The Boeing Company
P.O. Box 3707
Seattle, WA 98124-2207

September 8, 2017
DAT-2017-065

Subject: Formal Dispute Resolution – Ecology’s Final Decision under Informal Dispute Resolution Regarding the Upland Feasibility Study Report, dated July 20, 2017, and Written Statement of Boeing’s Position on Disputed Items for the Boeing Everett Facility

Figure 8-24 (Revised 9/1/17)
Present Worth Cost vs. Overall Weighted Benefit
Powder Mill Gulch SWMU

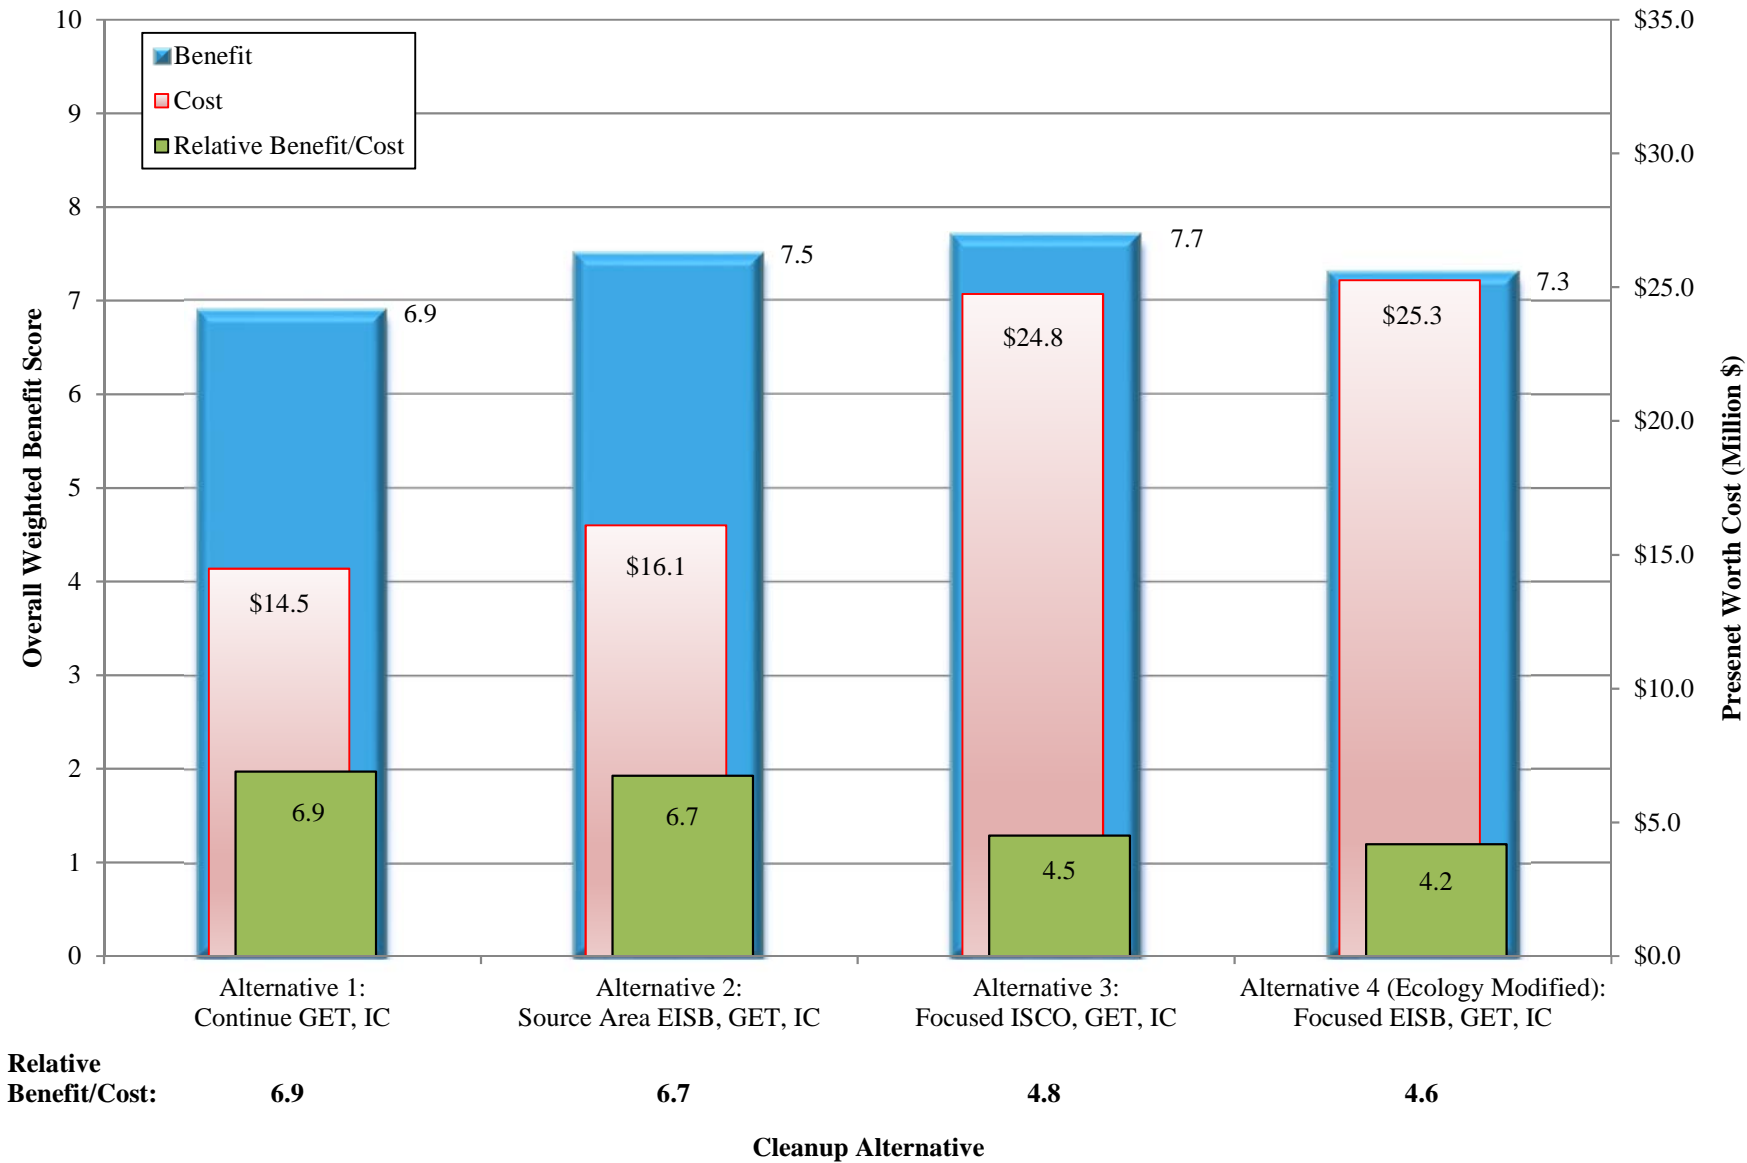
- **Boeing's Response:** Based on the estimates provided in Landau's November 2016 technical memorandum, the estimated cost difference between these alternatives was actually over \$8 million (\$16.69M for Alternative 2 and \$24.76M for Ecology's modified Alternative 4). The current updated costs (see Attachment 1D), based on the updated modeling results and lower assumed cleanup level,⁷ are nearly \$11 million (\$25.26M for Ecology's modified Alternative 4 and \$14.48M for Alternative 2). Ecology's conclusory statement that the comparative costs are not disproportionate fails to provide any analysis based on the MTCA standard. WAC 173-340-360(3)(e)(i) defines when costs are disproportionate as “Costs are disproportionate to benefits if the incremental costs of the alternative over that of a lower cost alternative exceed the incremental degree of benefits achieved by the alternative over that of the other lower cost alternative.” As Boeing demonstrated above, Ecology's modified Alternative 4 is likely to cause unnecessary and significant risk of hazardous and/or deleterious substance discharge to Powder Mill Creek and to do damage to the very successful GET system. And, as discussed above and
